Re: Indian Point Unit No. 3
Docket No. 50-286
NL-03-140

Subject: **Reply to Request for Additional Information
Regarding NRC Order EA-03-009 Relaxation Request (TAC MB8163)**

**RESPONSE TO NRC QUESTIONS REGARDING
NRC ORDER EA-03-009 RELAXATION REQUEST
PERTAINING TO INSPECTION OF THREADED REGION OF NOZZLES**

**RELAXATION REQUEST REGARDING ULTRASONIC TESTING OF
REACTOR PRESSURE VESSEL HEAD NOZZLES
IN ACCORDANCE WITH NRC ORDER EA-03-009, SECTION IV. F.
(REVISION 1)**

FIGURE 1
 IP3 PENETRATION NOZZLES
 HEAD NOZZLE WELD AREA

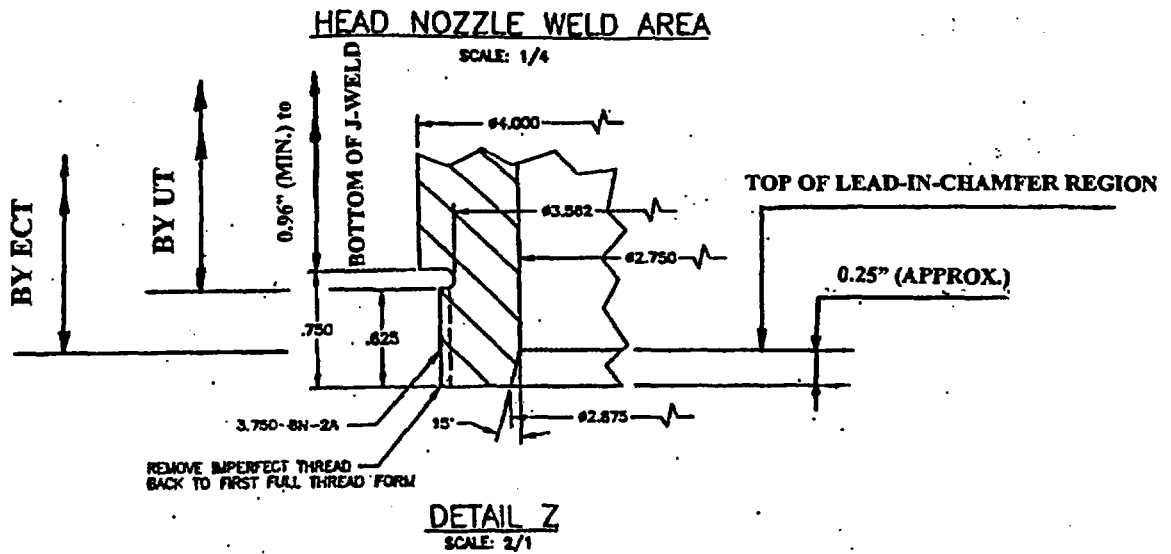
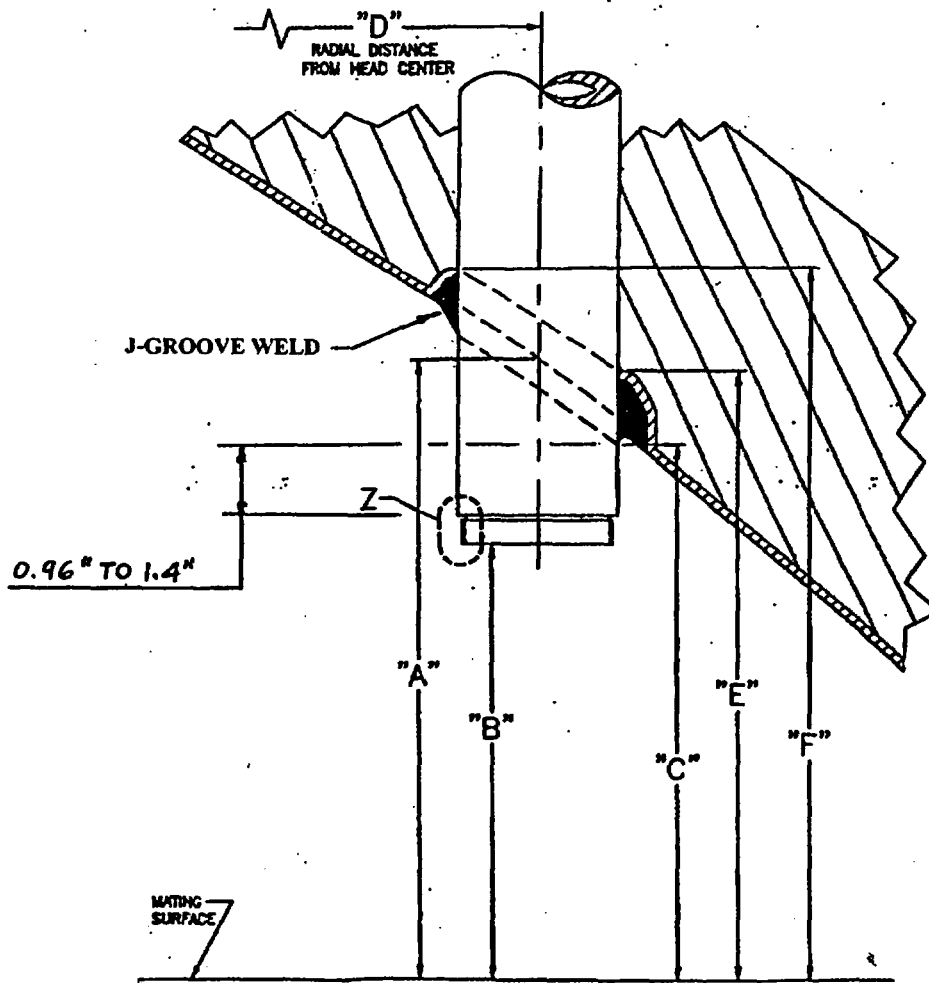
The licensee stated that a structural evaluation was performed for the IP3 nozzles.

Provide the applicable technical data (i.e., operating stress levels, crack growth analysis, hoop stresses, etc) which supports the conclusion that the area in the threaded region is insignificant.

The licensee stated that if cracking is detected above the threaded region, and extends into the threaded area, other nondestructive examination (NDE) methods would be used to determine the extent of cracking.

Identify the particular NDE methods that would be utilized, and provide the justification why this additional NDE would not be proposed / performed as an alternative to the requirements in the Order.

The structural evaluation for Indian Point 3 consists of a crack growth analysis using the methods of MRP-55 for crack growth caused by primary water stress corrosion cracking at a head temperature of 592 degrees F. The nozzle is an open-ended tube so that the operating pressure and temperature are essentially the same at both the inside and outside surface of the tube. Therefore the operating stress levels are negligible for this case. For purposes of this analysis, a conservatively high hoop stress of 30 ksi is assumed. An initial hypothetical flaw is assumed to exist with a worst-case orientation (axial) and flaw growth occurs in a single direction toward the J-groove weld. Because the location of the hypothetical flaw is in the threaded region, at least 0.96 inches from the J-groove weld, the weld residual stresses are also negligible. The analysis concludes that crack growth in a 4-year operating period is approximately 0.54 inches, well within the minimum dimension of 0.96 inches to the closest point of the J-groove weld. Refer to Figure 1 in the relaxation request for the location of these dimensions on the penetration nozzles.

case, non-destructive examination of the RPV head penetration nozzles is required by the Order. However, the bottom 0.75 inches of the nozzles are designed with a threaded region to accommodate the installation of guide funnels (Figure 1). Based on experience gained during the inspection in 3R12, meaningful ultrasonic test data cannot be obtained in this region, due to dispersion of the ultrasonic test signal. Therefore, the relaxation request is needed to support a non-destructive examination of the RPV nozzles based on use of ultrasonic test methods.

Entergy will perform ultrasonic testing of each RPV head penetration nozzle (i.e., nozzle base material) from two (2) inches above the J-groove weld and extending down the nozzle to the top of the threaded region, which is approximately 0.75 inches above the bottom of the nozzle.

The ultrasonic testing will extend from two (2) inches above the J-groove weld to the top of the threaded region at the bottom of the penetration nozzle. The axial dimension from the bottom portion of the J-weld (at the lowest point) to the top of the threaded region ranges from 0.96 inches to 1.4 inches, depending on the radial location of the nozzle. This coverage provides an acceptable level of quality and safety because:
